Transport Assessment Addendum

Symmetry Park, Ardley

Tritax Symmetry Ardley Limited

30 April 2024

General Arrangement and RSA1 Response Plan

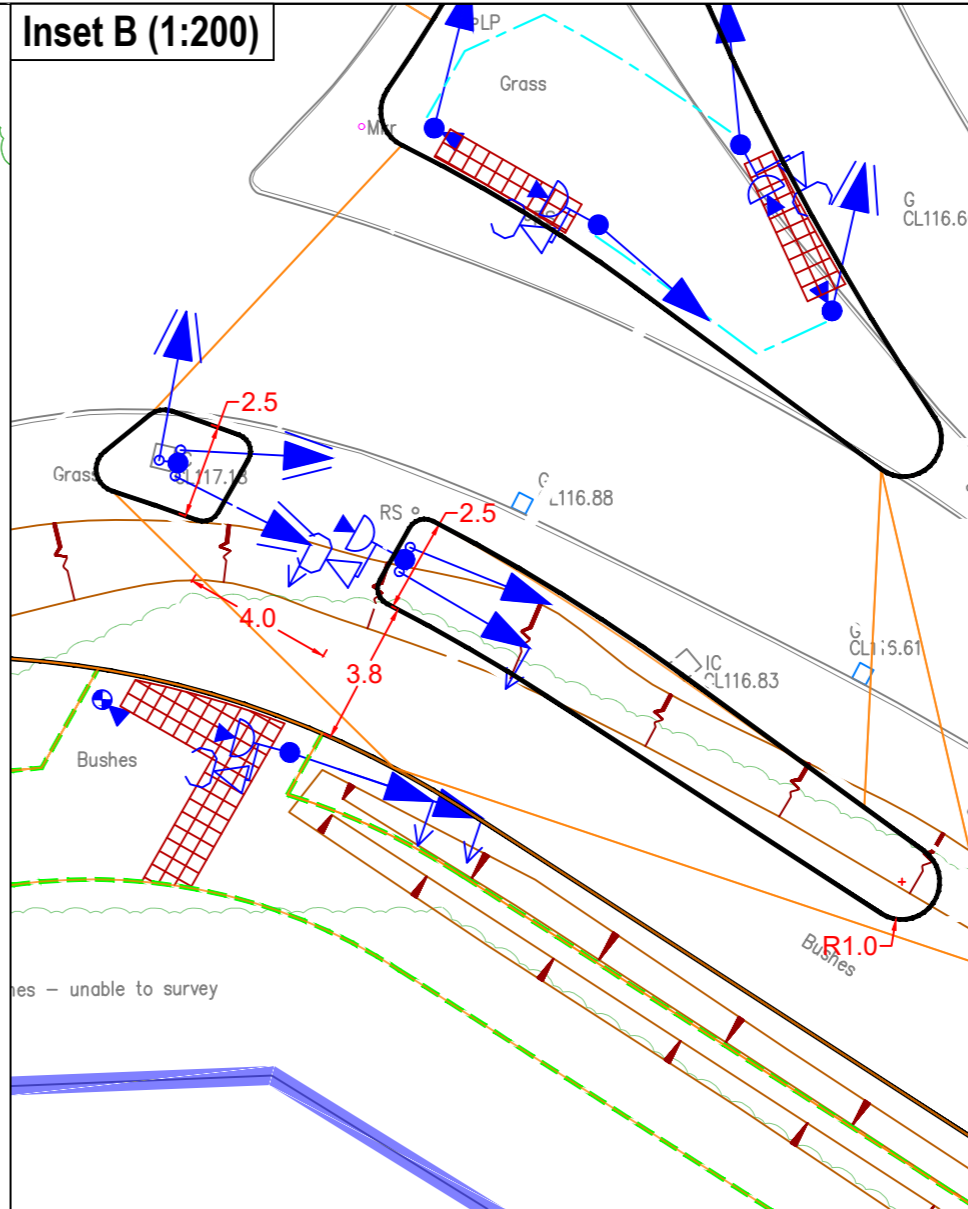
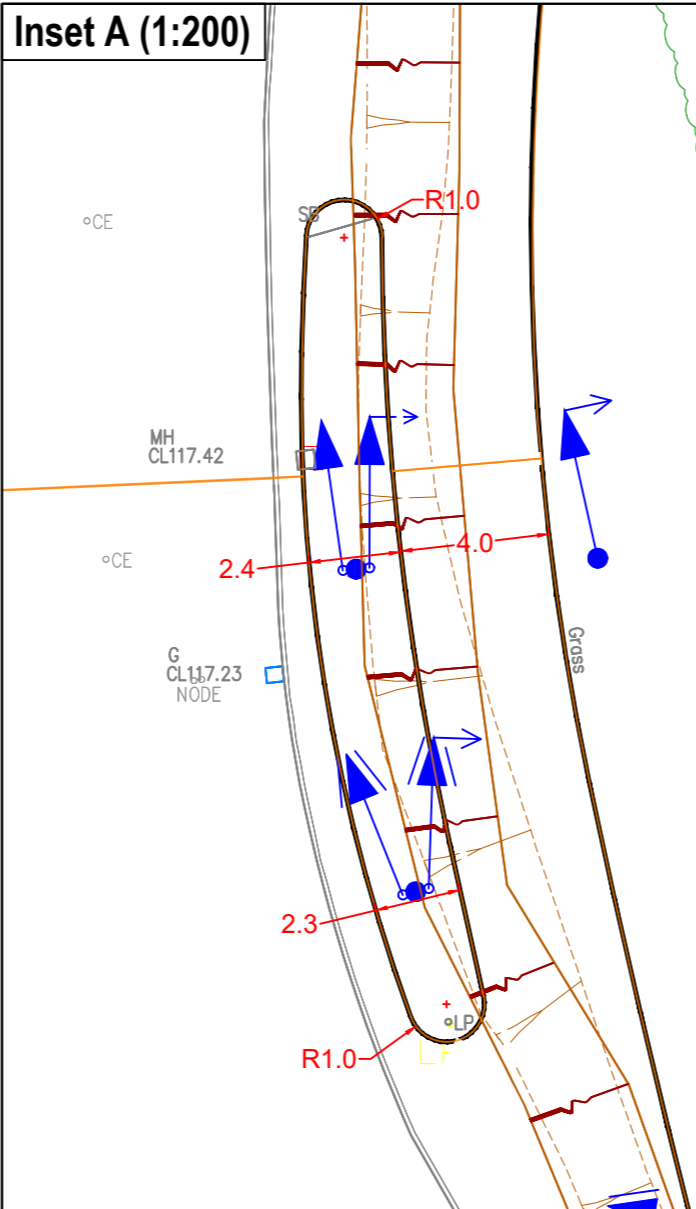
RSA1 2.1: Grasscrete Maintenance Access to signal control equipment to be positioned in the central island.

RSA1 2.6: Highways boundary to be revised in TSL land to maintain 120kph visibility splay.

RSA1 2.9: Fencing to be provided to deter pedestrians from crossing the A43 North.

Figure 3: Link and Priority Rule Locations for Network Changes

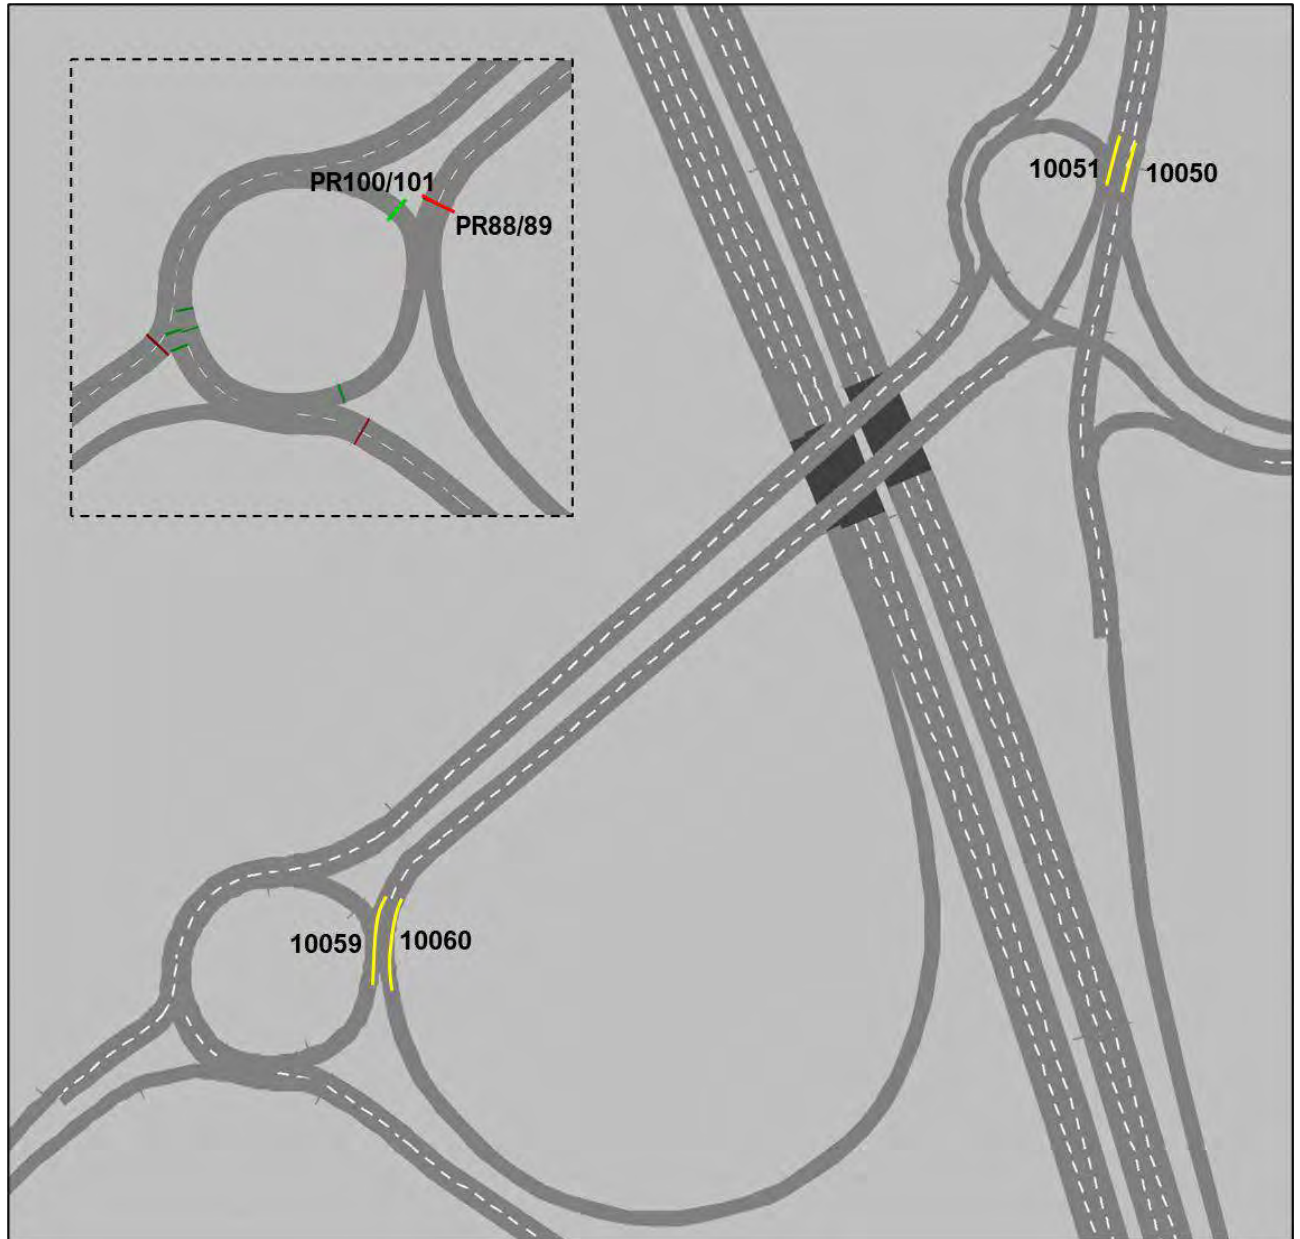
- i. Priority Rule 88 (Lights), Min.Gap time changed from 4s to 2.4s
- ii. Priority Rule 89 (Heavies), Min.Gap time changed from 4.5s to 2.8s
- iii. Priority Rule 100 (Heavies), Min.Gap time changed from 4.5s to 2.8s
- iv. Priority Rule 101 (Lights), Min.Gap time changed from 4s to 2.4s

16. Regarding connectors 10050 and 10051, the lookback distance was increased to encourage earlier lane change to prevent unrealistic lane changing on the section between Padbury and Cherwell. The emergency stop distances were reduced to prevent vehicles in Lane 2 of Link 2 stopping to change lane into Lane 1 (due to original emergency stop distance on connector 10051); originally this behaviour caused bottlenecks on Link 2 and prevented vehicles from accessing Lanes 2 and 3 of Link 36.

Figure 4: Original A43 Lane Change Behaviour between Padbury and Cherwell

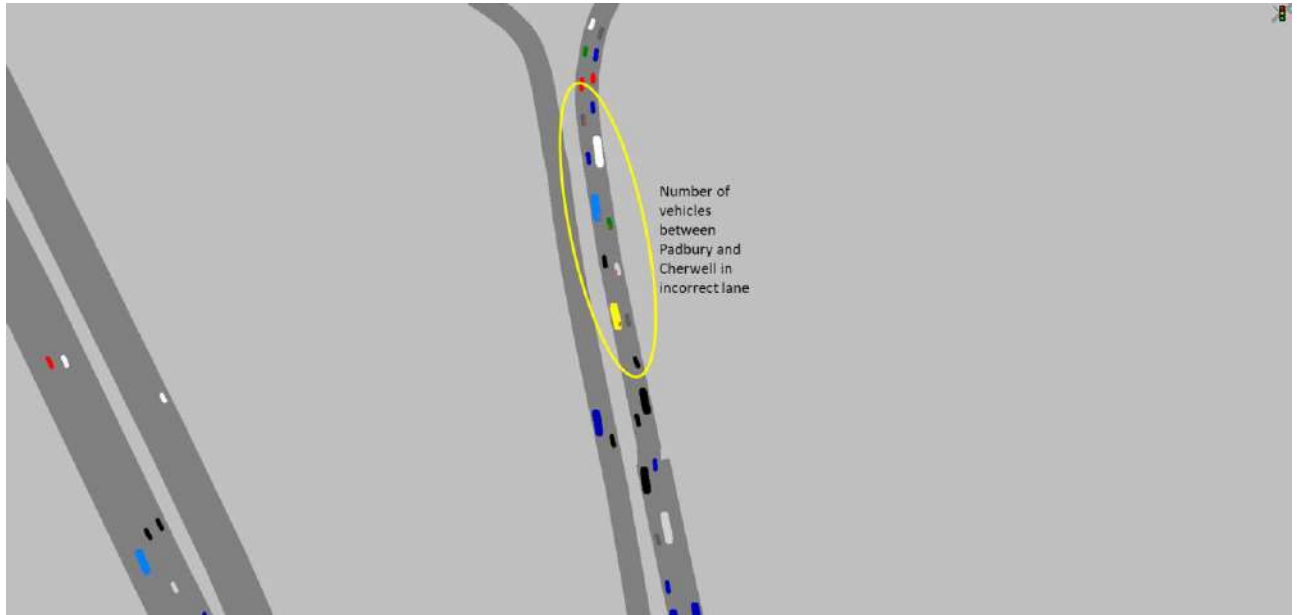
17. **Figures 4 and 5** below show vehicles approaching Cherwell in the incorrect lane, and bottlenecks occurring due to the original emergency stop distances:

Figure 4: Original A43 Lane Change Behaviour between Cherwell and Ardley

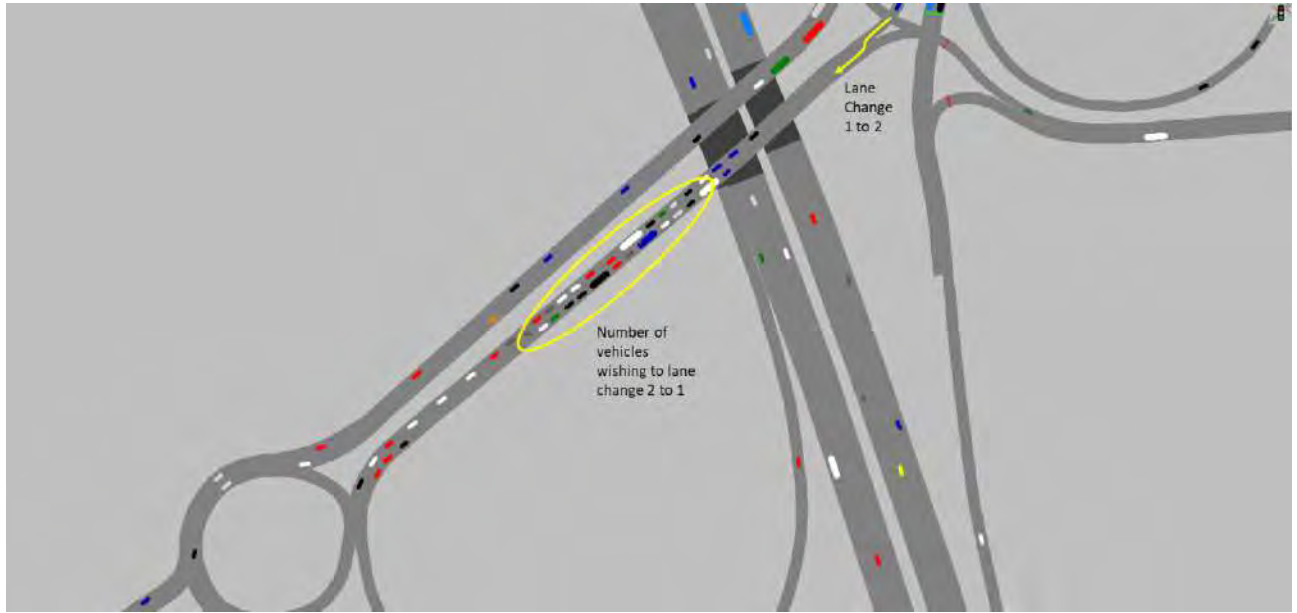
18. The look back distance on connectors 10059 and 10060 was revised to prevent unrealistic lane change behaviour on the A43 bridge over the M40. The distance between these connectors and connector 10053 (the single lane connector which routes vehicles from the A43 north of Cherwell Services junction to the A43 bridge) is approximately 240m, while the original look back distance was

200m. This resulted in a number of trips joining the bridge in lane 1, changing to lane 2 and then immediately looking to change back to lane 1. This is observed in the screenshot below:
